Re: Sunport Apartments
Mulberry & Bethel
Lots A1 thru F1 & Lots 1A, Block 10, Unit 3
Traffic Circulation Layout
Engineer's/Architect's Stamp 11-29-18 (M15D036)

Based upon the information provided in your submittal received 11-29-18, the above referenced plan cannot be approved for Building Permit until the following comments are addressed:

SHEET NUMBER
AS-1.0

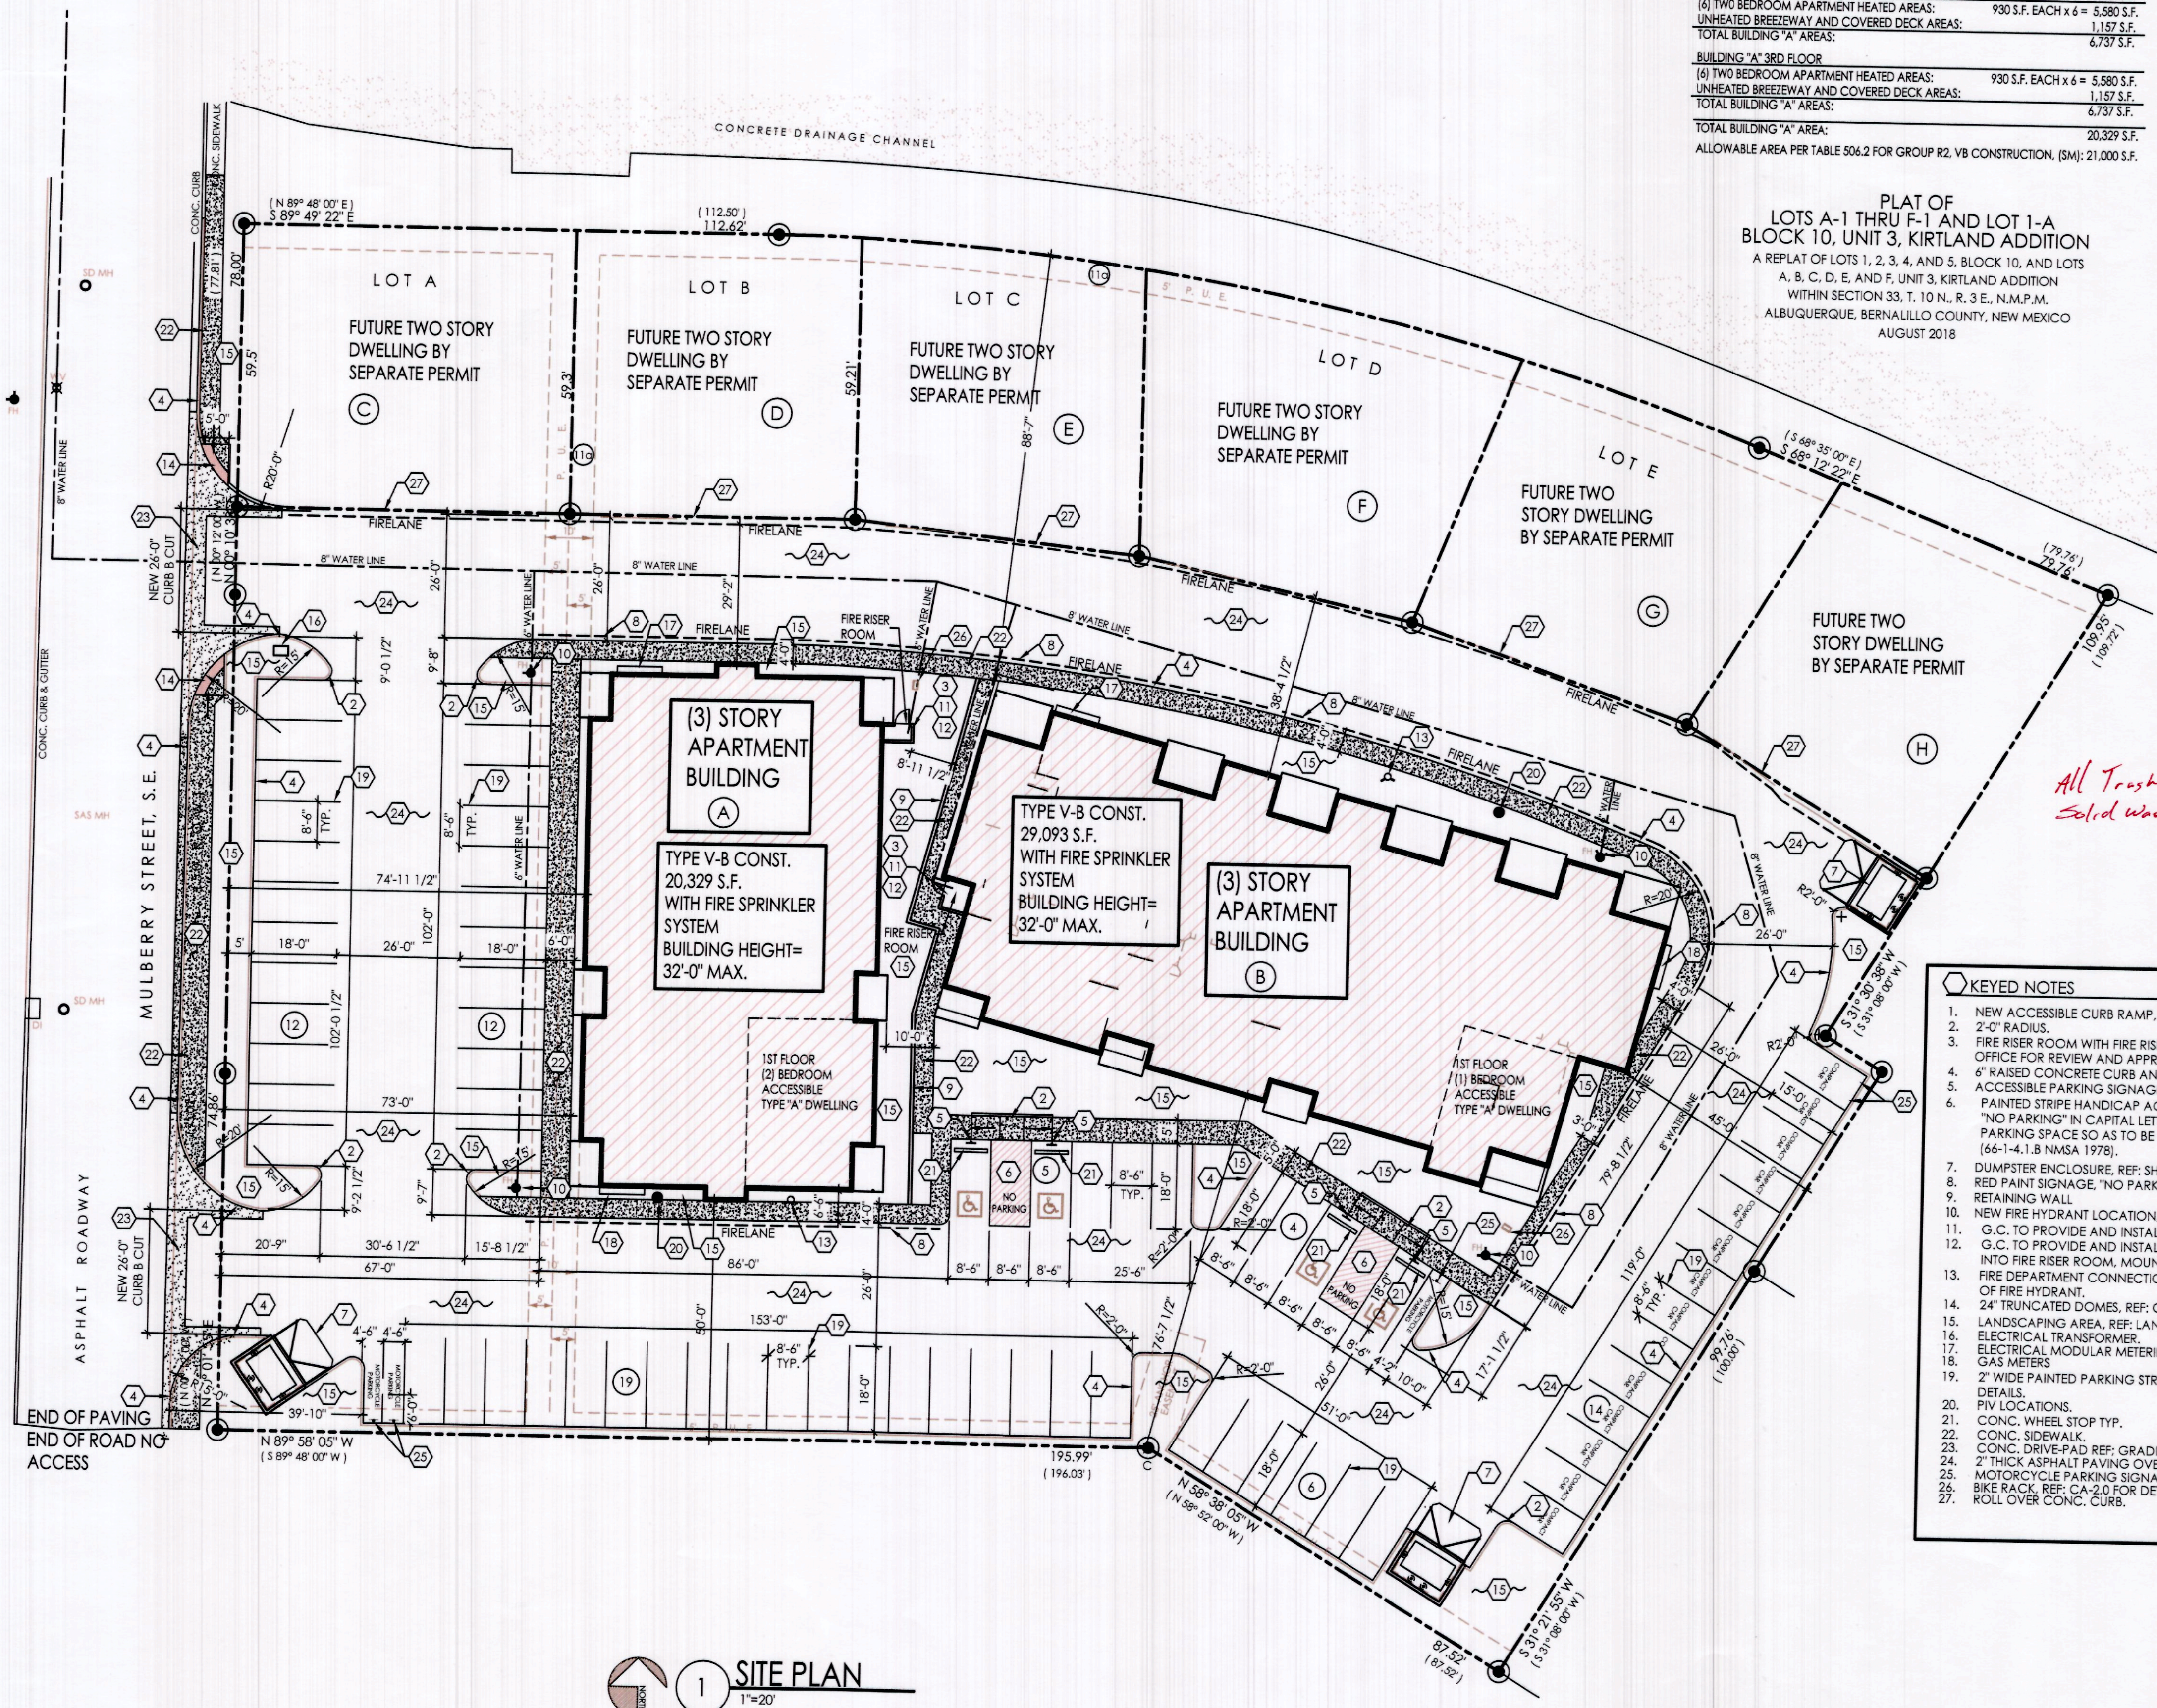
1. List the number of parking spaces required by the zoning code as well as the proposed number of parking spaces including bicycle and motorcycle parking.
2. The scale must be shown on the plan. Per the Development Process Manual, Chapter 27, Section 2, Part B.1, on the following scales may be used:

$1" = 20'$
 $1" = 40'$
 $1" = 100'$ (for overall layouts only)
3. Per the IDO, a 6 ft. wide ADA accessible pedestrian pathway is required from the public sidewalk to the building entrances. Please clearly show this pathway and provide details.

4. Per DPM, a 6 ft. wide ADA accessible pedestrian pathway is required from the HC parking stall access aisles to the building entrances. Please clearly show this pathway and provide details.

5. ADA accessible pedestrian pathway should not be placed behind parking space or adjacent to a vehicular way. Vehicle and pedestrian/wheel chair conflicts should be avoided as much as possible.

6. Please provide a sight distance exhibit
7. Show the clear sight triangle and add the following note to the plan:
"Landscaping and signage will not interfere with clear sight requirements. Therefore, signs, walls, trees, and shrubbery between 3 and 8 feet tall (as measured from the gutter pan) will not be acceptable in the clear sight triangle."

8. Please specify the City Standard Drawing Number when applicable.

9. Provide notes showing what work is included and on the work order and the private work on site.
10. Work within the public right of way requires a work order with DRC approved plans.
11. Please add a note on the plan stating "All improvements located in the Right of Way must be included on the work order."
12. Please clarify Key Note #2 is referencing correct location on site plan.
13. Please include one copy of the traffic circulation layout at the next submittal.
